UNITED STATES
DEPARTMENT OF THE INTERIOR
BUREAU OF LAND MANAGEMENT
SUNDRY NOTICES AND REPORTS ON WELLS

PROPOSED PLUG & ABANDONMENT

**Arco 20 Federal Com 2
Devon Energy Production Company, LP
July 31, 2007
Plug and Abandonment
Conditions of Approval**

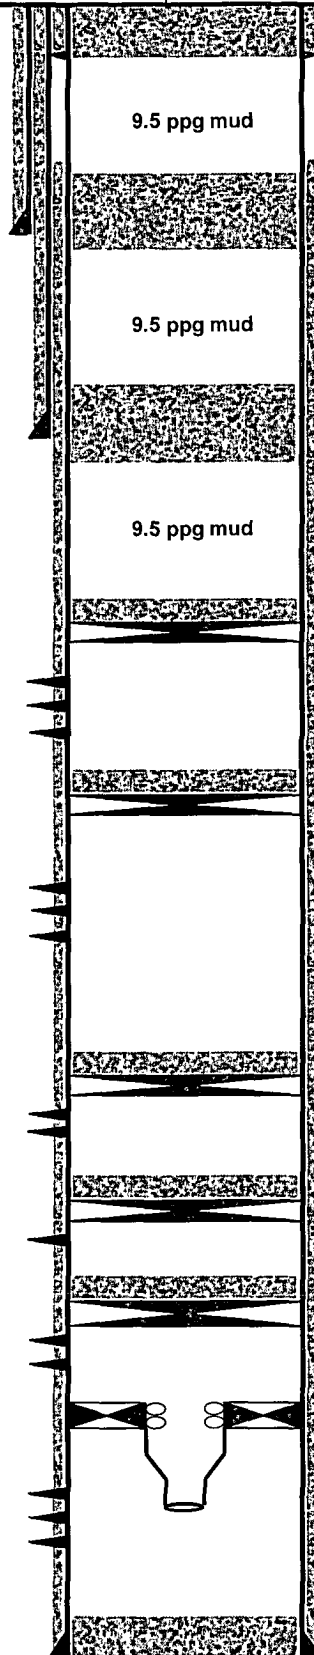
1. CIBPs at 3090' and 3250' must be drilled out due to inadequate plugs below CIBP at 3250'.
 - a. Plug required at top of Wolfcamp at 8400'. Plug to be set at 8450' and be 185' in length, minimum of 25 sacks.

- b. Plug required due to spacing requirement of no more than 3000' between plugs in casing. Set plug at approximately 6500'. Plug to be 165' in length, minimum of 25 sacks.

- c. Plug required at top of Bone Spring at 4549'. Plug to be set at 4600' and be 150' in length, minimum of 25 sacks.
 - d. Replace plugs for Brushy Canyon or pump sufficient cement to extend 50' below lowest perforation at 3886' and 50' above highest perforation at 3140' (approximately 145 sacks). If cement is pumped, plug is to be tagged.

2. Plug to be extended to top of Delaware at 2341'. Plug to be set at 2400' and include shoe plug. Tag plug at 2060' or shallower.
3. Geological report when well was drilled indicated fresh water to 650'. Plug to be extended to cover this depth inside the casing (approximately 50 sacks). Tag plug at 390' or shallower.

4. Minimum 25 sack plug per NMOCD guidelines.
5. Ok
6. Ok
